## SELF-COOLING AND ALARM

DEVELOPMENT BOARD

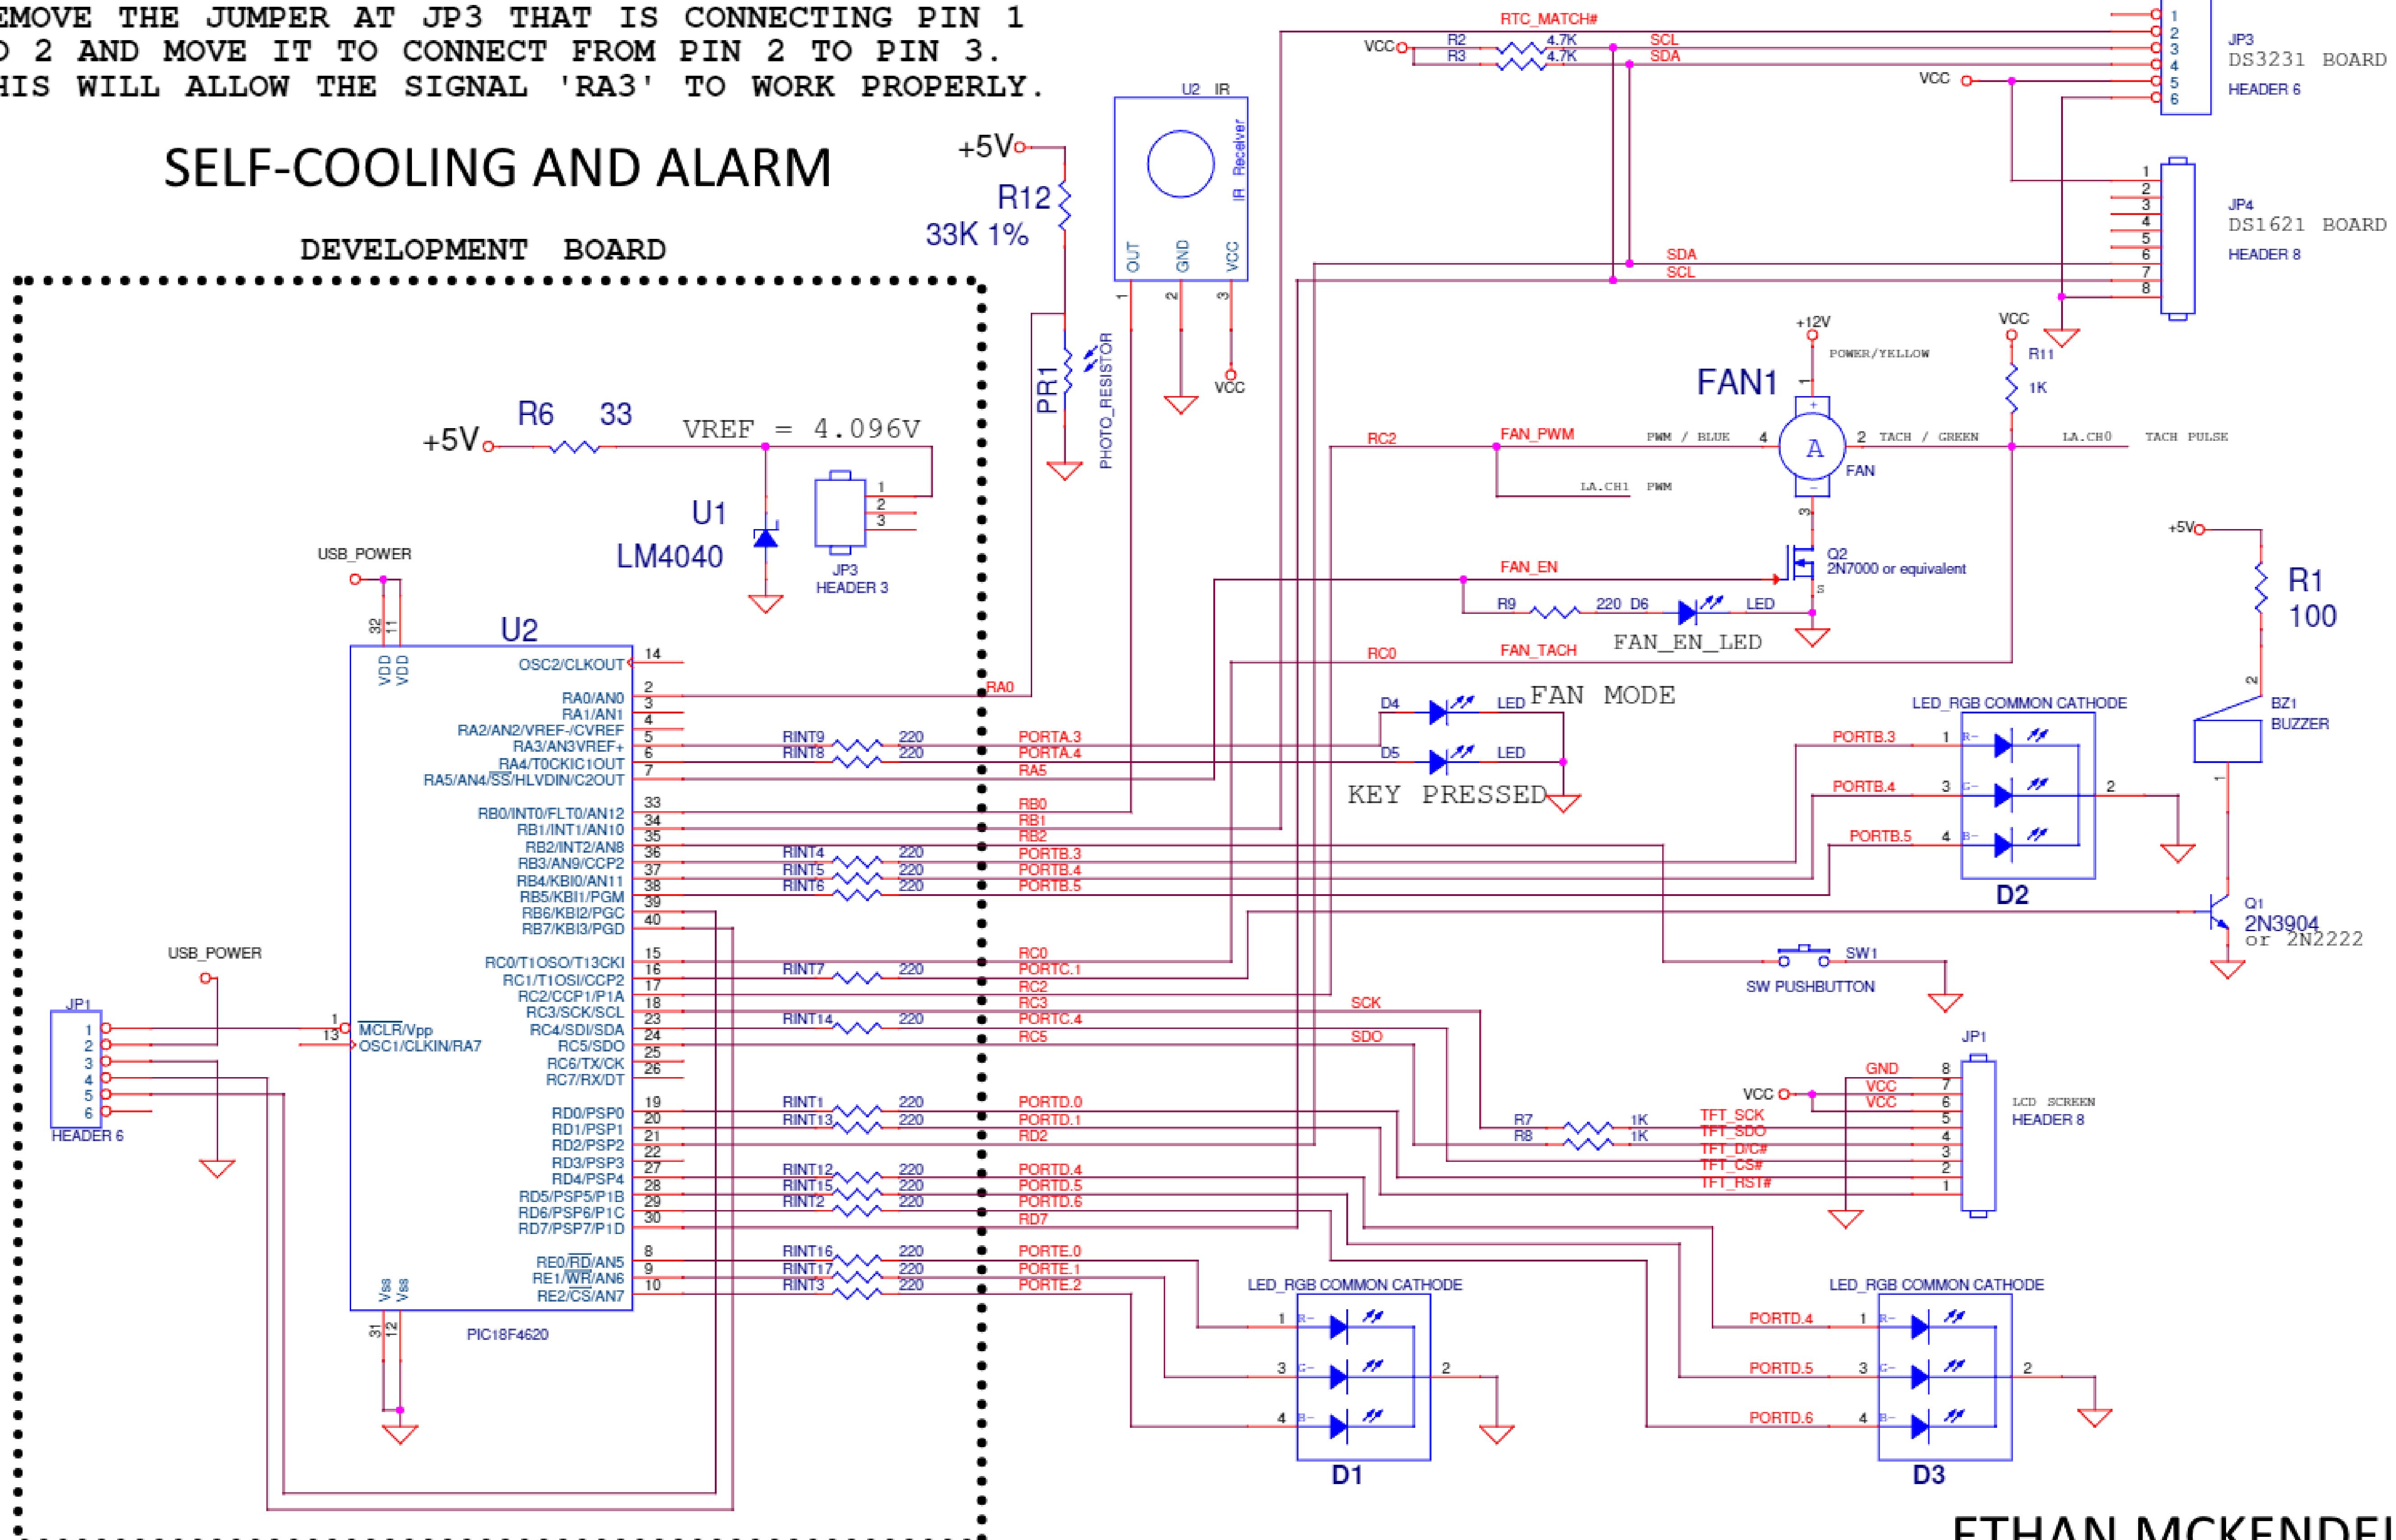
REMOVE THE JUMPER AT JP3 THAT IS CONNECTING PIN 1 TO 2 AND MOVE IT TO CONNECT FROM PIN 2 TO PIN 3. THIS WILL ALLOW THE SIGNAL 'RA3' TO WORK PROPERLY.
